ADDENDUM NO. 2

JOB NO. 2019-1109

**'ŌLA'A #3 CHLORINATION SYSTEM REPLACEMENT
DISTRICT OF PUNA
County of Hawai'i – State of Hawai'i**

DEPARTMENT OF WATER SUPPLY COUNTY OF HAWAII	
PROJECT OLA A STATION NO. 3 PRODUCTION WELL AND SUPPORTING FACILITIES	
PIPELINE PROFILES	
JOB NO. 88461	
SHEET NO. 11 OF SHEETS	PART A

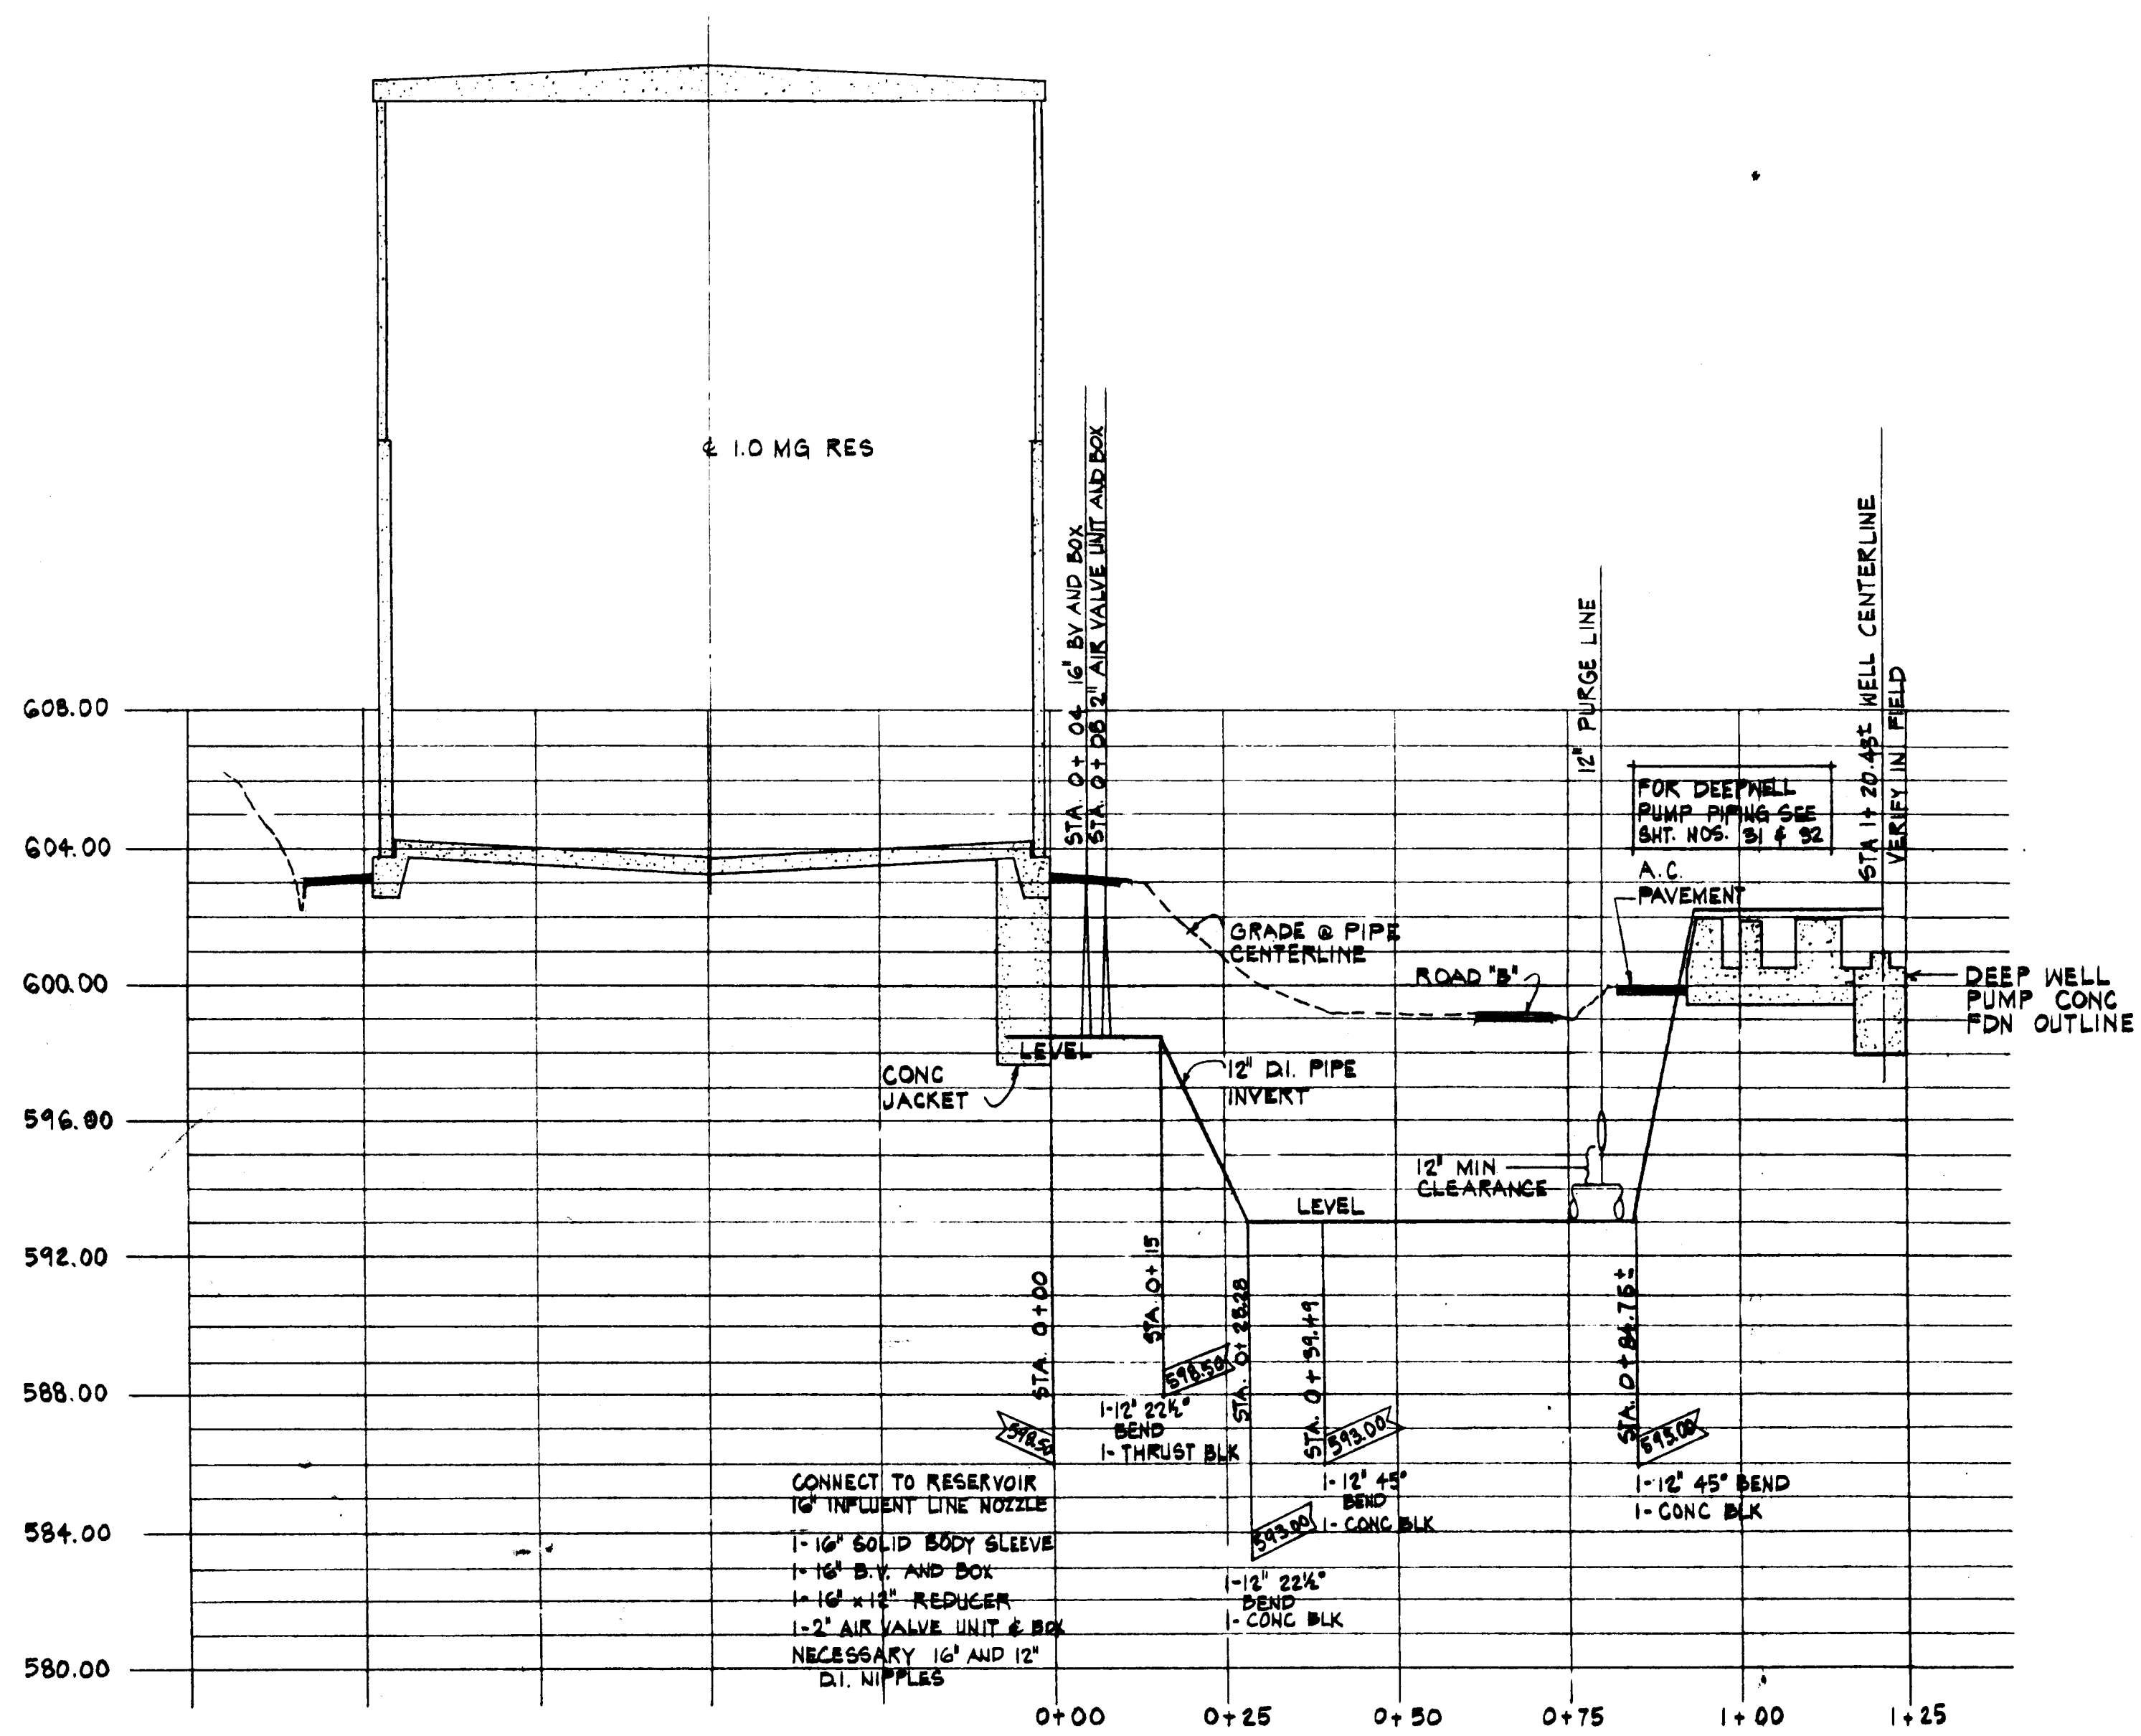
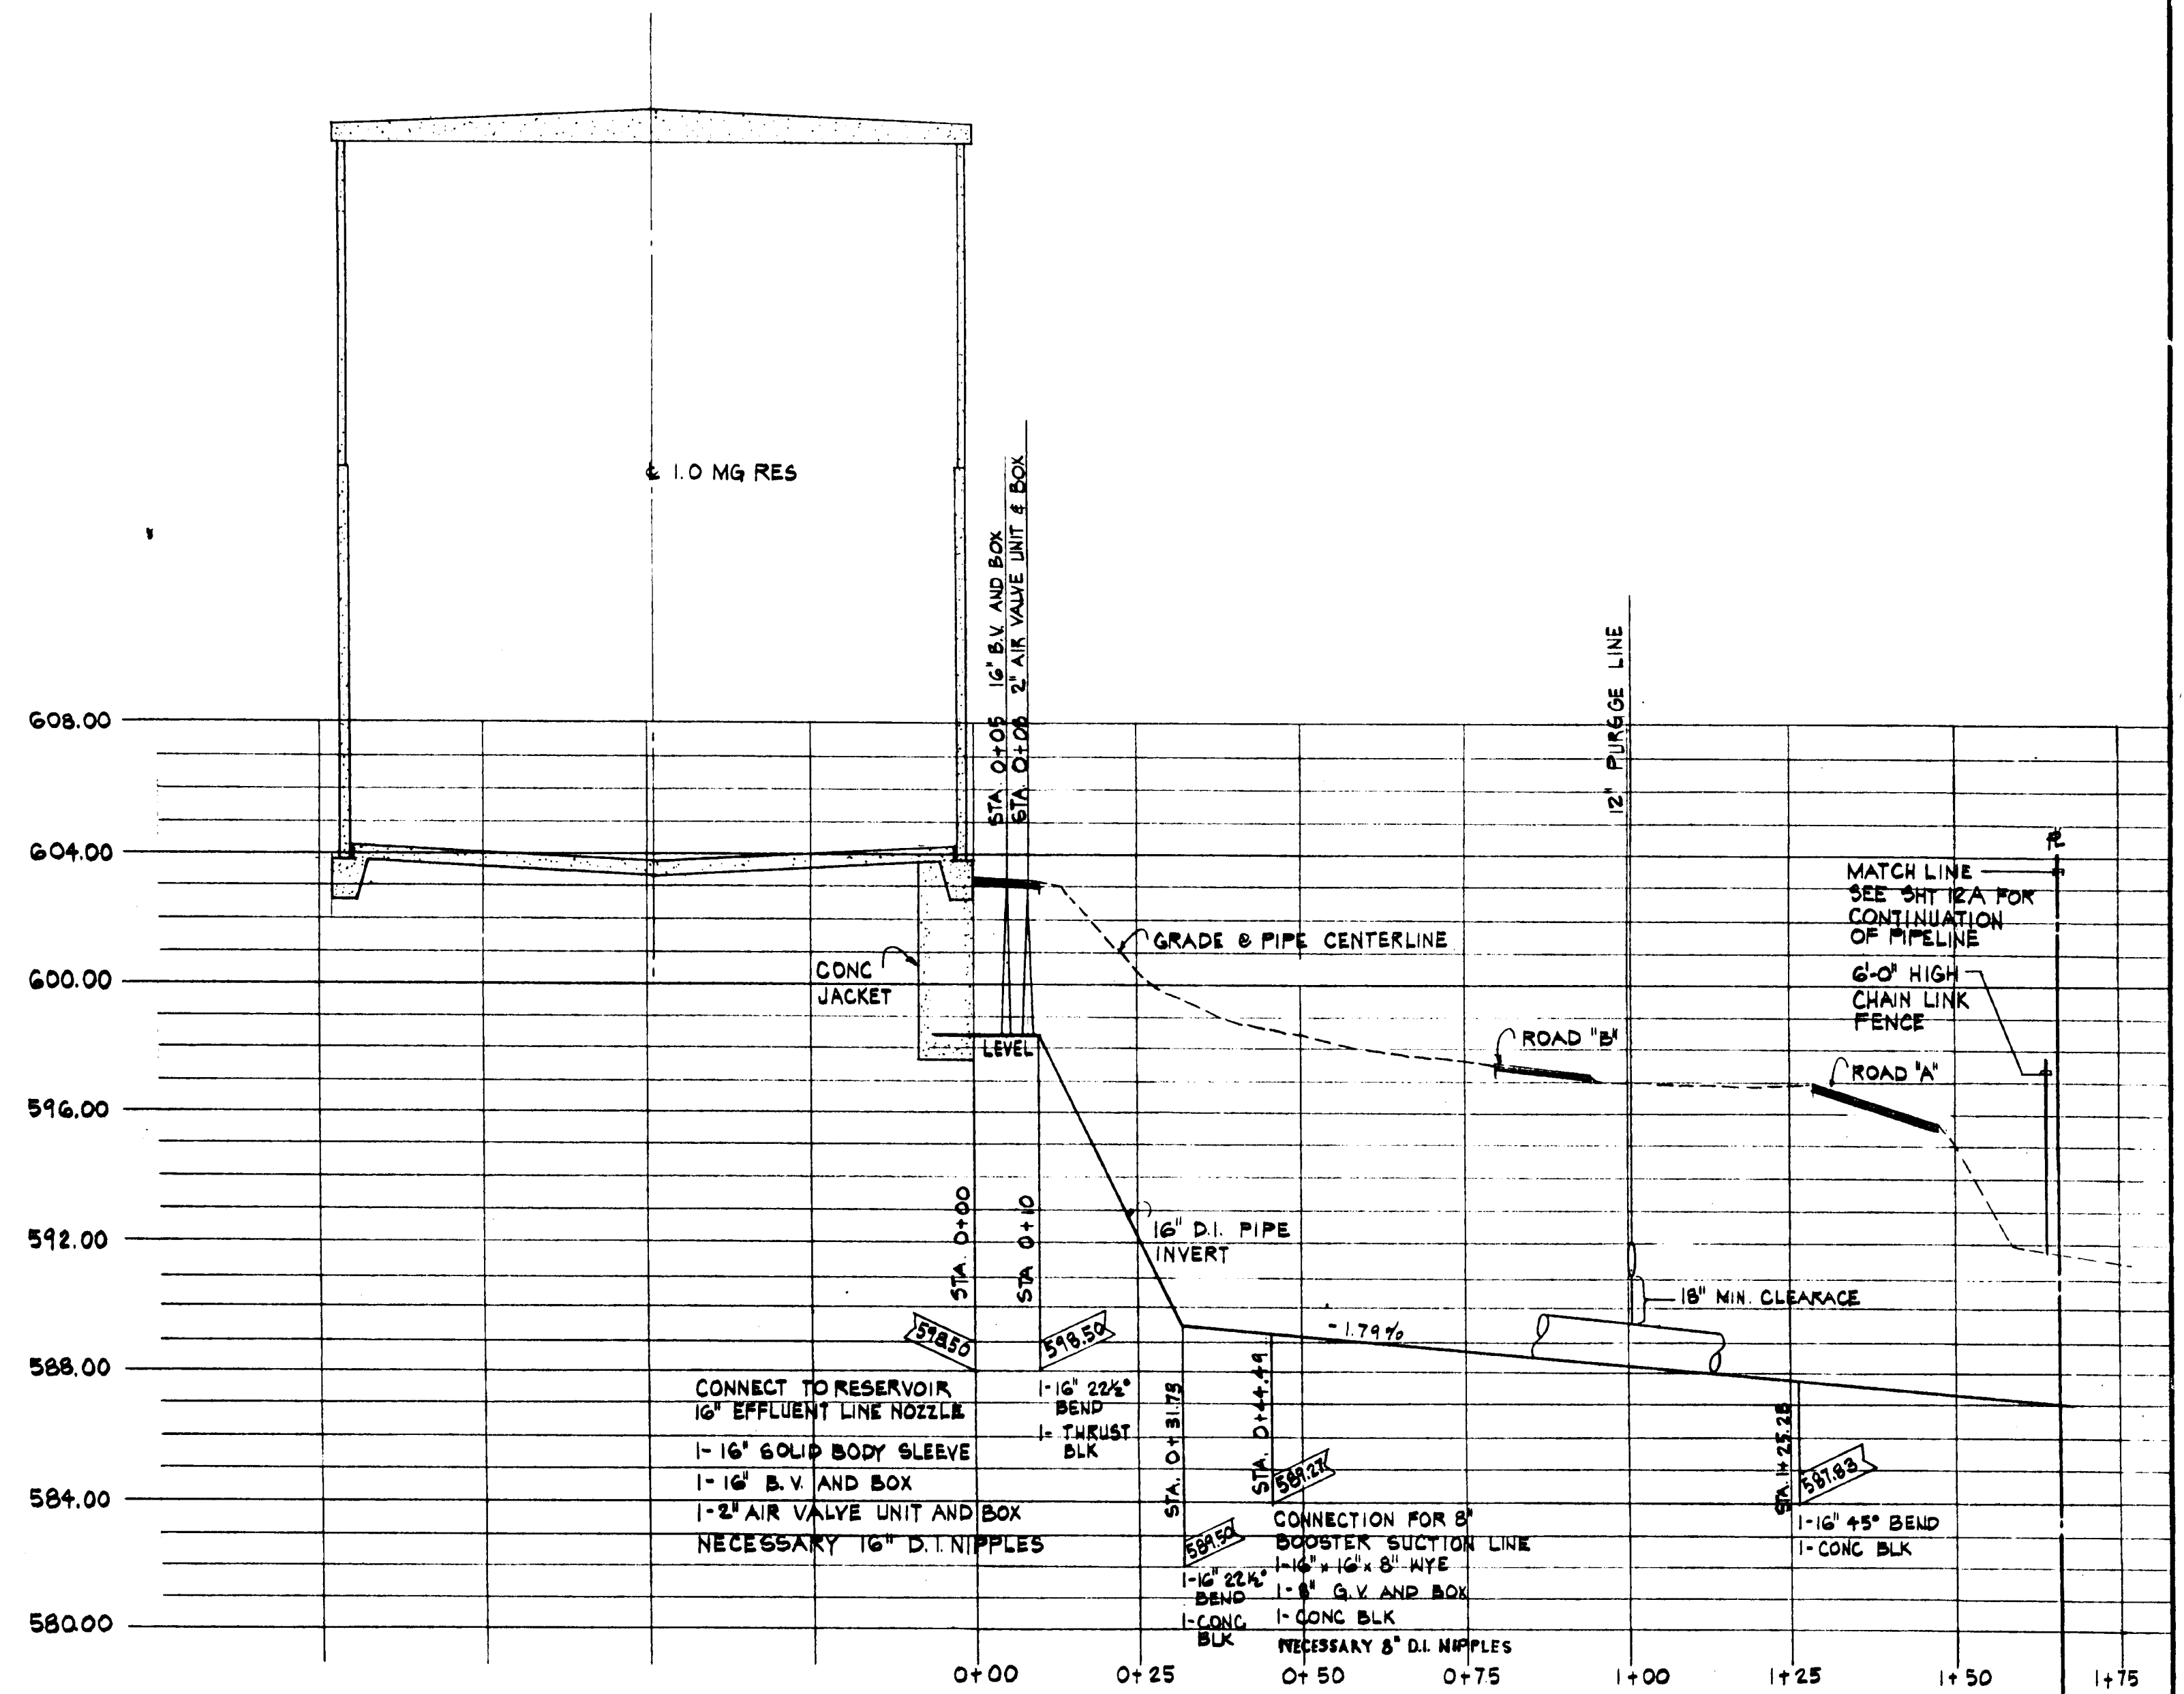
- a. Photos of the chlorination room access and existing conditions have been attached for bidders' reference.
- b. As-built drawing for the reservoir 12" influent piping and 16" effluent piping has been attached for bidders' reference. At the point of intersection with the proposed trench for new electrical and signal conduits, the depth of the 12" influent piping is approximately 5' below the existing grade, and the depth of the 16" effluent piping is approximately 4.5' below the existing grade, as determined by the as-built drawing. The Contractor shall be required to tone the line and verify depth in the area of work prior to commencing trenching work.
